TEXAS INSTRUMENTS

## 2. Question

LVDS Channel A

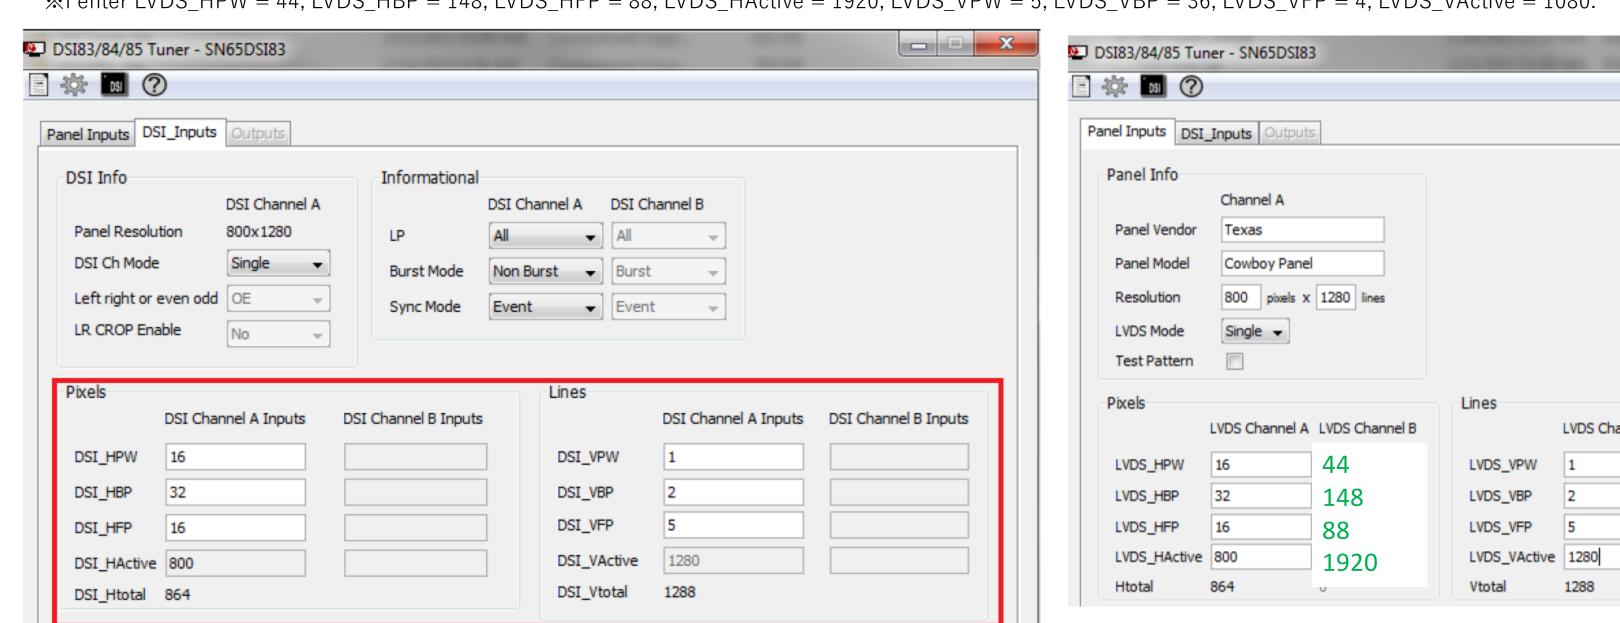
## Q1 What should I enter for DSI\_HPW, DSI\_HBP, DSI\_HFP, DSI\_VPW, DSI\_VBP, DSI\_VFP?

፠I think the number of NOPs will change for each LINE. Therefore, I do not know how to set it. XI enter LVDS\_HPW = 44, LVDS\_HBP = 148, LVDS\_HFP = 88, LVDS\_HActive = 1920, LVDS\_VPW = 5, LVDS\_VBP = 36, LVDS\_VFP = 4, LVDS\_VActive = 1080.

Q2 What should I enter for CHA\_SYNC\_DELAY\_LOW and CHA\_SYNC\_DELAY\_HIGH? Should I enter 2200? CHA\_SYNC\_HIGH=0x8, CHA\_SYNC\_LOW=0x98
